Interactive comment on “Which rainfall metric is more informative about the flood simulation performance? A comprehensive assessment on 1318 basins over Europe” by Stefania Camici et al.

Received and published: 8 June 2020

Figure 1. Relationship between basin area and KGE-Q for the analysed catchments.

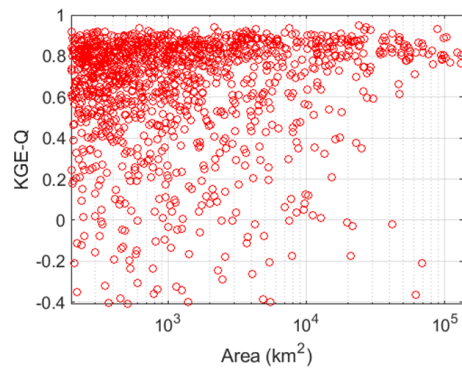
1. Line 158-169: the E-OBS dataset is built on a station network with an average station density of 1 in 4000 km² and the basin areas range from 200 to 136’000 km². Is the E-OBS dataset a reliable benchmark for the smaller basins? Maybe it is worth to discuss this in your discussion section.

R: In the submitted version of the paper, an error occurred in the definition of station used within the E-OBS datasets. Indeed, 2316 stations (i.e., equivalent on average to a density of 1 station every 4000 km²) is referred to the first versions of E-OBS whereas

in the version 17 (used in the manuscript) the number of stations increased up to 9618 (equivalent on average to a density of 1 station every 1000 km²). However, as correctly raised by the reviewer even the E-OBS density network referred to version 17 could be too low to correctly represent the rainfall spatial variability over small basins. This, in turn could affect the discharge simulation. To consider this aspect, it has been verified that 1) for all the analysed basins the KGE-Q values obtained by the calibration of the model by using E-OBS dataset as input were greater than -0.41, i.e., the model improves upon the mean flow benchmark 2) no relationship between basin area and KGE-Q exists (see Figure 1). As these conditions were satisfied and as the purpose of the study was to investigate the performances between rainfall and discharge time series (without specific focus on high and/or low flows), the limitations about the E-OBS station density can be assumed to have a negligible impact for the analysis purpose.

Accordingly, two sentences will be added in the revised version of the manuscript (on section 5.2): “The results of this calibration, carried out for the entire observation period (2007-2016), are good as illustrated in Figure 3a: for all the analysed basins the KGE-Q values are greater than -0.41, i.e., the model improves upon the mean flow benchmark and the median KGE-Q value obtained for the European area is equal to 0.768 (0.770 over the TMPA area). In addition, to take into account that due to the density network, E-OBS rainfall data could be not reliable for smaller basins (area < 1’000 km²) the relationship between basin area and KGE-Q has been investigated (not shown). As no relationship was found, and as the purpose of the study is to investigate the performances between rainfall and discharge time series (without specific focus on high and/or low flows), the limitations about the E-OBS station density can be assumed to have a negligible impact on the analysis results and QE-OBS data can be assumed as a good benchmark for the successive analysis.”
